Access Compliance Report

Public Rights-of-Way

Intersection ID: 18920	Main Street: TYVOLA_RD	Cross Street: WESTPARK_DR	Location: SE
ADA ID: 1AB8A2DFB8C8	Ramp Type: PerpDiag	Initial Pass/Fail: Fail	Overall Compliance: No
		Severity Score: 35

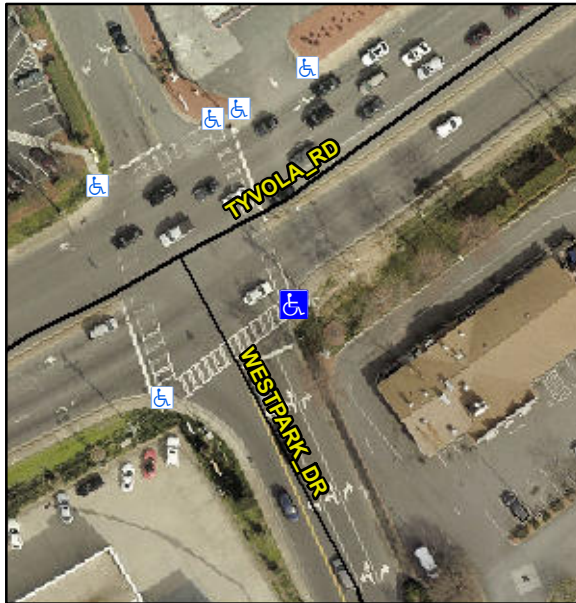
Not Found, R304.5.1, R304.2.2, R304.5.3

Compliance	Description	Data	Compliance	Description	Data
N/A	Ramp Length (in)	60.0	No	Ramp Slope (%)	12.1
No	Ramp Width (in)	38.5	No	Ramp XSlope (%)	2.7
N/A	Flare Type LT	N/A	N/A	Flare Type RT	N/A
N/A	Flare Slope LT (%)	N/A	N/A	Flare Slope RT (%)	N/A
N/A	Flare Traversable LT?	N/A	N/A	Flare Traversable RT?	N/A
N/A	Landing Length (in)	N/A	N/A	DWS Provided?	N/A
N/A	Landing Width (in)	N/A	N/A	DWS Contrast?	N/A
N/A	Landing Slope (%)	N/A	N/A	DWS Length (in)	N/A
N/A	Landing X Slope (%)	N/A	N/A	DWS Full Width?	N/A
N/A	Landing Curb? (Y/N)	N/A	N/A	DWS Offset (in)	N/A
N/A	Shared Landing?	N/A			
N/A	Gutter Ponding?	N/A	N/A	Gutter Slope (%)	N/A
N/A	Gutter Lip Ht (in)	N/A	N/A	Gutter X Slope (%)	N/A
N/A	Painted X Walk1?	Yes	N/A	Painted X Walk2?	Yes
	X Walk 1 Direction	To NW		X Walk 2 Direction	To SW
N/A	X Walk 1 Width (in)	67.0	N/A	X Walk 2 Width (in)	106.0
	X Walk 1 Slope (%)	1.9		X Walk 2 Slope (%)	1.7
	X Walk 1 X Slope (%)	1.9		X Walk 2 X Slope (%)	1.8

Remove & Replace Curb Ramp With Two New Directional Ramps or Equivalent.
